Access Compliance Report

Public Rights-of-Way

(Pedestrian Signals)

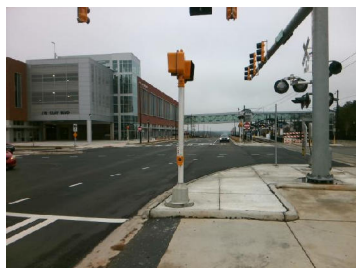
PROW/ADA: TMUTCD 4e.08, R404.2, R404.7.3, R404.7.2, R209.1, MUTCD 4e.10

N/A	B 1 Clear Xing Direction?	Yes	N/A	B 2 Clear Xing Direction?	N/A
	B 1 Crossing Direction	To NW		B 2 Crossing Direction	N/A
Yes	B 1 DistanceTo XWalk (in)	13.0	N/A	B 2 DistanceTo XWalk (in)	N/A
No	B 1 DistanceTo Curb (in)	4.0	N/A	B 2 DistanceTo Curb (in)	N/A
Yes	B 1 Diameter (in)	2.0	N/A	B 2 Diameter (in)	N/A

Possible Solutions: Replace Signal Push Button With APS Button on New Post. Remove & Relocate Sign.
